## 3.4 18-30 Whitehorse Road Deepdene - Mixed-use Development - PP22/0319

### 18-30 Whitehorse Road, Deepdene

<b>Application no.:</b>	<b>PP22/0319</b>
<b>Responsible director:</b>	<b>Scott Walker, Director Urban Living</b>
<b>Authorised by:</b>	<b>David Cowan, Manager Planning and Placemaking</b>
<b>Report officer:</b>	<b>Jack Richardson, Senior Urban Planner</b>

## PLANNING ASSESSMENT

**Figure 12 - Proposed Street Wall and Upper Storey Setback**

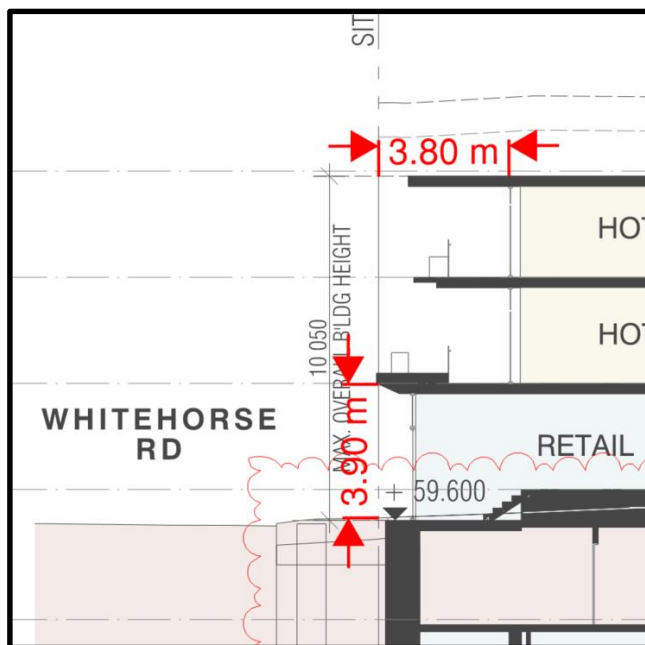
Relevant Requirement	Required	Proposed
Maximum Street Wall Height	8 metres	3.9 metres (See Figure 12)
Preferred Minimum Upper Storey Setback	3 metres	3.8 metres (See Figure 12)
Maximum Overall Building Height	12 metres (Due to slope of the site)	12 metres
Primary Street Frontage Setback	1.6 metres or on the frontage if up to the street wall height	✓
Side Street Frontage Setback	Development above street wall height should be setback 1.6 metres up	N/A- the site is not located on corner

Figure 1: An extract of the ground floor plan marked up with potential improvements.

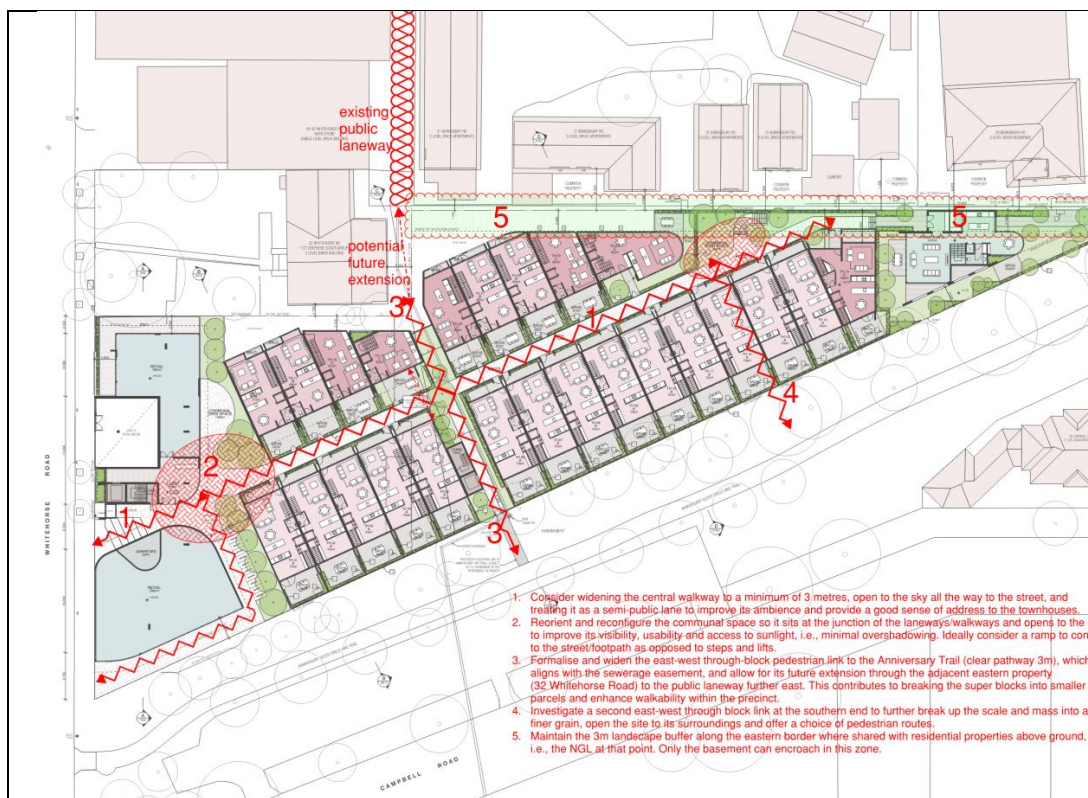
Breaking the super-block into a series of smaller volumes is one of the most prominent and positive features of the design concept, if not the top strength of the scheme. By doing so, the design reinstates the fine-grain subdivision pattern and ameliorates any adverse impacts of site consolidation, which often produces large, impermeable bulky buildings. That said, the current site layout needs attention and refinement in a few areas as outlined below and marked on the extracted ground floor plan in Figure 1:

- e. Ensure a 3m landscape buffer is maintained above ground along the eastern boundary where shared with residential properties. This may require rejigging and reshaping the private residence at the bottom of the site, at the triangle tip. Only the basement can extend into the 3m setback requirement with allowance for planting on top.

As relevant to the eastern interface, the DDO's requirement for a 3m setback from any boundaries shared with residential properties is twofold. First, it aims to minimise any off-site impacts, and secondly, to create a landscape buffer between the commercial and residential properties. Therefore, it needs to be maintained above ground and planted, as depicted in Figure 1.

#### **Trees 16 - Anniversary trail tree**

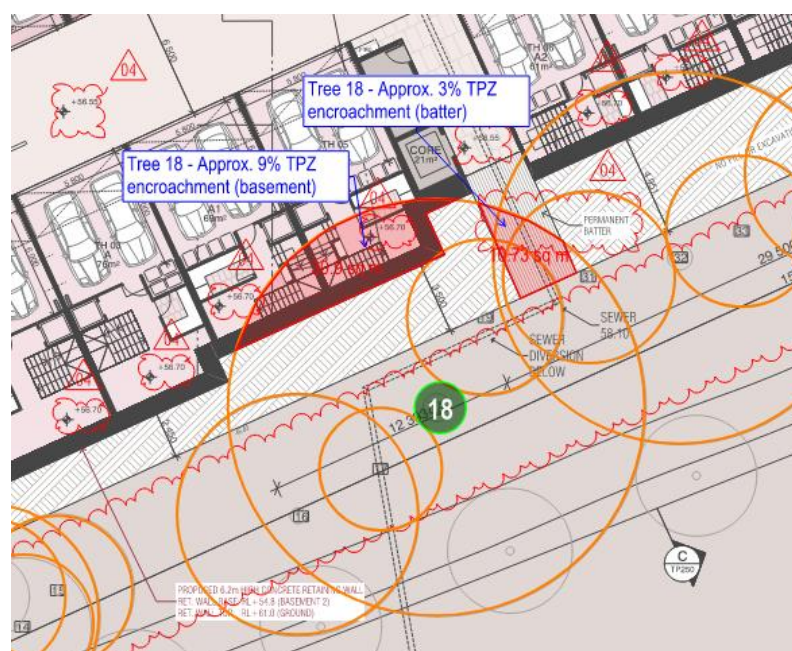
The TPZs of these trees appear to have a minor encroachment into the subject site which is unlikely to impact the tree. The proposed sewer diversion is within the outer TPZ area of this tree and has the potential to impact, although part of the sewer is existing. Root sensitive excavations and arborist supervision is advised. Works are not on private land.

**Tree 29 - Neighbouring tree**

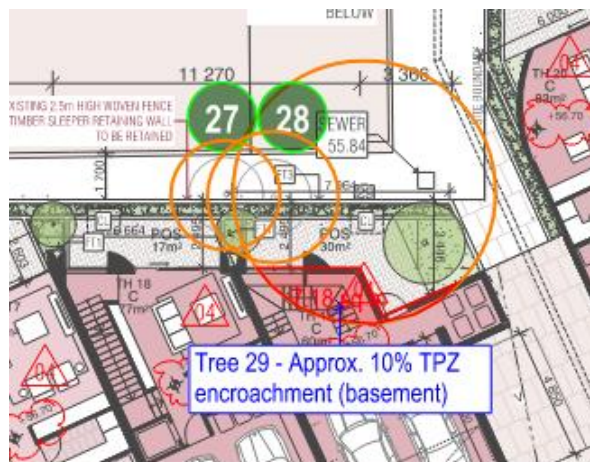
The proposed basement represents a TPZ encroachment of approx. 10% which is considered minor and unlikely to impact the tree. The tree is currently below the ground level of the subject site, with a retaining wall on the boundary and a further retaining wall offset inside the property. These retaining walls are likely to have reduced root spread into the subject site. Maintaining of existing grade within the TPZ of this tree (outside basement) and utilising predominantly permeable surfaces, this tree is unlikely to be impacted. Given the species and condition of the tree, the tree owner could be approached regarding its removal, which would likely be supported by Council.

*Above - Side and Rear Setback Calculation Points 2 and 3 (red arrows indicated assessment points)*

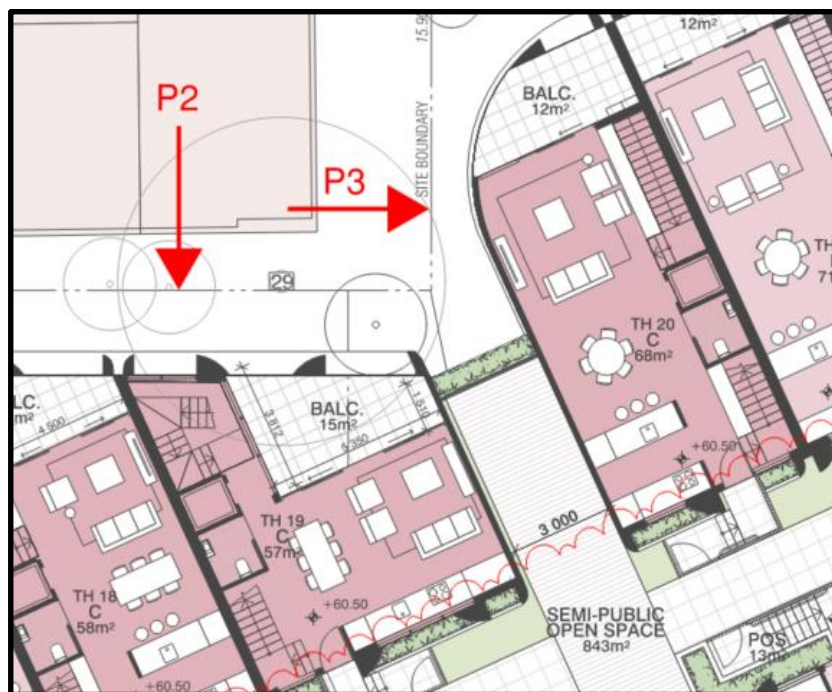
<b>Point 2 - Basement Level 1</b>				
	<b>Wall Height</b>	<b>Setback</b>	<b>Setback Required</b>	<b>Assessment</b>
East	3.46m	2.49m	1m	✓
<b>Point 2 - Ground Level</b>				
	<b>Wall Height</b>	<b>Setback</b>	<b>Setback Required</b>	<b>Assessment</b>
East	6.2m	2.5m	1.78m	✓
<b>Point 2 - First Floor Level</b>				
	<b>Wall Height</b>	<b>Setback</b>	<b>Setback Required</b>	<b>Assessment</b>
East	9.35m	3.5m	4.44m	* (Variation Supported - No Impact on Non-residential neighbouring Property)
<b>Point 2 - Second Floor Level</b>				
	<b>Wall Height</b>	<b>Setback</b>	<b>Setback Required</b>	<b>Assessment</b>
East	12.4m	3.5m	7.49m	* (Variation Supported - No Impact on Non-Residential Neighbouring Property)

As shown in the below photo, the areas on non-compliance are adjacent to the rear of the Scout Hall located at 32 Whitehorse Road, which is used for storage/rubbish disposal. Further, the building located at 32 Whitehorse Road is a significantly graded heritage property, and therefore the proposed non-compliance will not compromise any future development on the neighbouring site.

*Above - Side and Rear Setback Calculation Point 4 (red arrows indicated assessment points)*

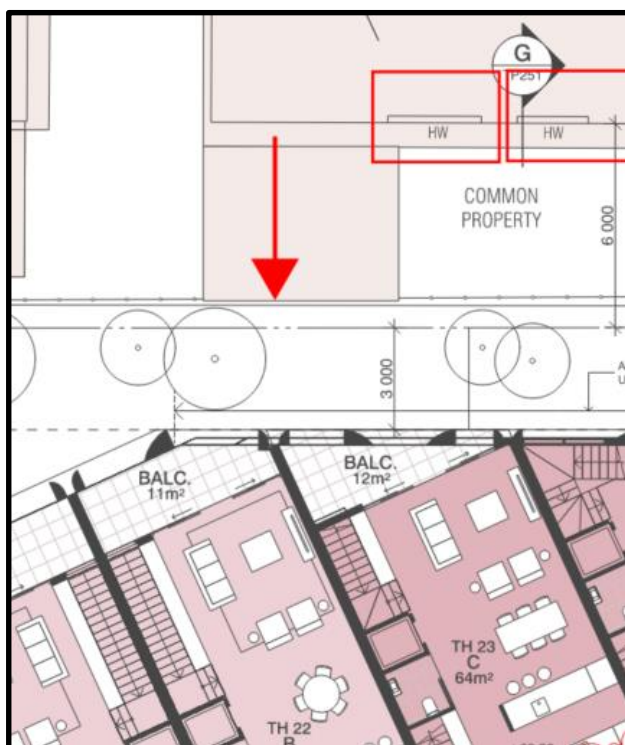
Point 4 - Basement Level 1				
	Wall Height	Setback	Setback Required	Assessment
East	2.8m	3.265m	1m	✓
Point 4 - Ground Level				
	Wall Height	Setback	Setback Required	Assessment
East	5.6m	3.921m	1.6m	✓
Point 4 - First Floor Level				
	Wall Height	Setback	Setback Required	Assessment
East	9.2m	4.5m	4.29m	✓
Point 4 - Second Floor Level				
	Wall Height	Setback	Setback Required	Assessment
East	12.1m	5.6m	7.19m	* (Variation Supported, see below)

*Above - Side and Rear Setback Calculation Point 6 (red arrows indicated assessment points)*

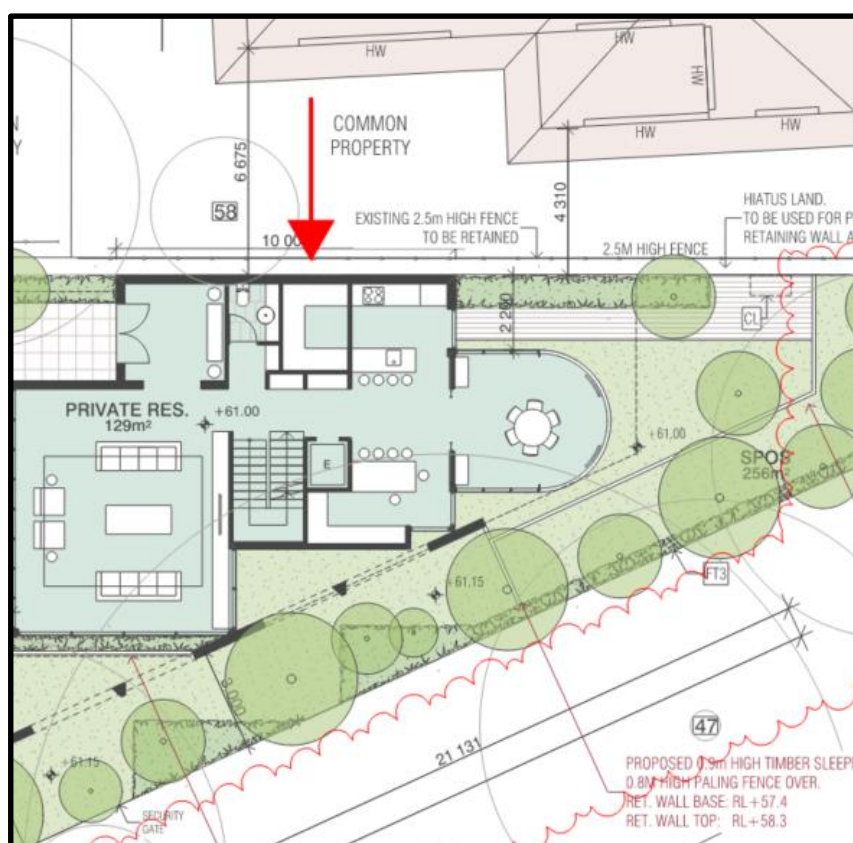
The second-floor non-compliance is acceptable as it is located adjacent to common property area at 31 Barnsbury Road, and is setback over 8 metres from the closest neighbouring dwellings.
